HL-4493

Edwin I. Hatch Nuclear Plant - Unit 2
Request to Revise Technical Specifications:
Increase in Allowable MSIV Leakage Rate and
Deletion of the MSIV Leakage Control System

Response to Request for Additional Information

Figure 1

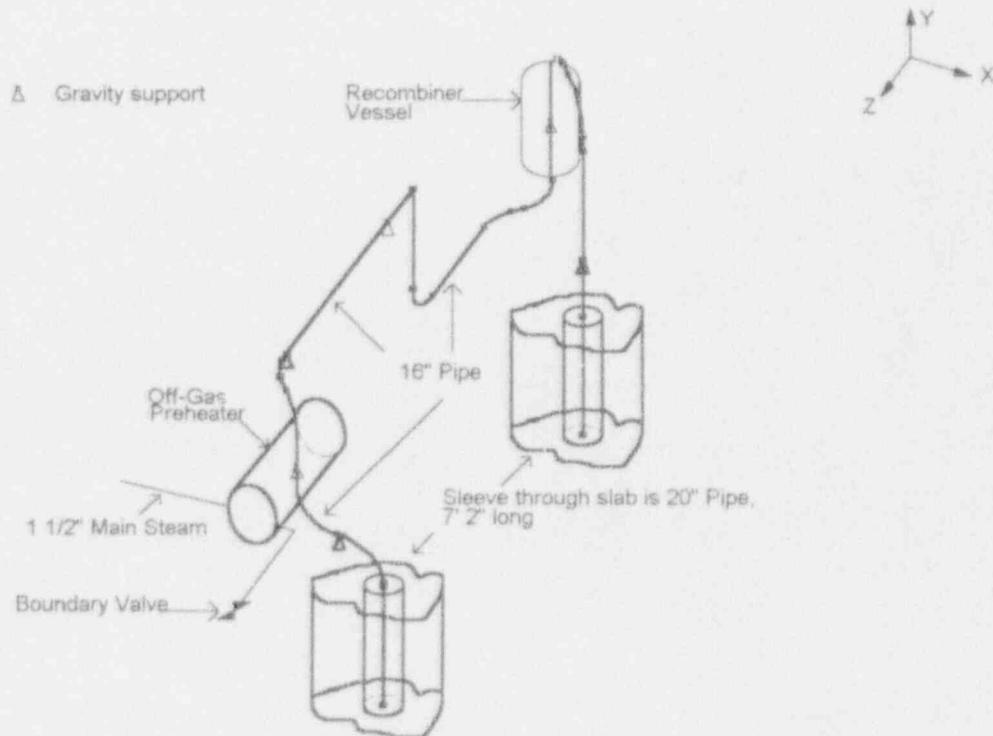
1. NRR Staff Comment:

The licensee should provide the evaluation that demonstrates the adequacy of the off-gas hydrogen recombiner system supports.

The identified leakage control path includes a 2 inch line which branches from the main steam line to the steam jet air ejectors line. This 2 inch line reduces to 1 1/2 inch, attaches to the tube side of the off-gas preheater, and terminates at the boundary valve downstream of the preheater. The shell side of the off-gas preheater has a 16 inch line which runs between the preheater and the hydrogen recombiner tank. Both the off-gas preheater and recombiner tank are spring-supported. The NRR staff comment was that if the recombiner tank fell off of its spring supports during a seismic event it then may impose large movements on the off-gas preheater, resulting in displacement-induced damage to the 1 1/2 inch line in the leakage control path.

The piping attached to the recombiner and preheater tank is very stiff. As shown in Figure 1, the 16 inch pipe goes through a 7 foot 2 inch long sleeve which penetrates the slab at elevation 112, both upstream and downstream of these vessels. The sleeve is made of 20 inch pipe; therefore, the movement of the pipe is limited to the gap inside the 20 inch pipe, which is approximately 2 inches.

Vertical movement of the piping is limited by the pipe and equipment spring supports, which allow approximately 2 inches of vertical motion before bottoming out. The support design has sufficient margin so that combined vertical loads due to seismic and dead weight are less than rated loads. From the piping computer analysis run, the horizontal movement at the recombiner due to seismic loading is determined to be approximately 2 inches. This movement would be insufficient to cause the recombiner tank to move off its spring supports.

An evaluation of the 1 1/2 inch line and its identified supports shows that it is flexible enough to accommodate seismic anchor motion of the vessel. Therefore, this seismic motion would not adversely effect the ability of the piping to maintain its pressure boundary role.
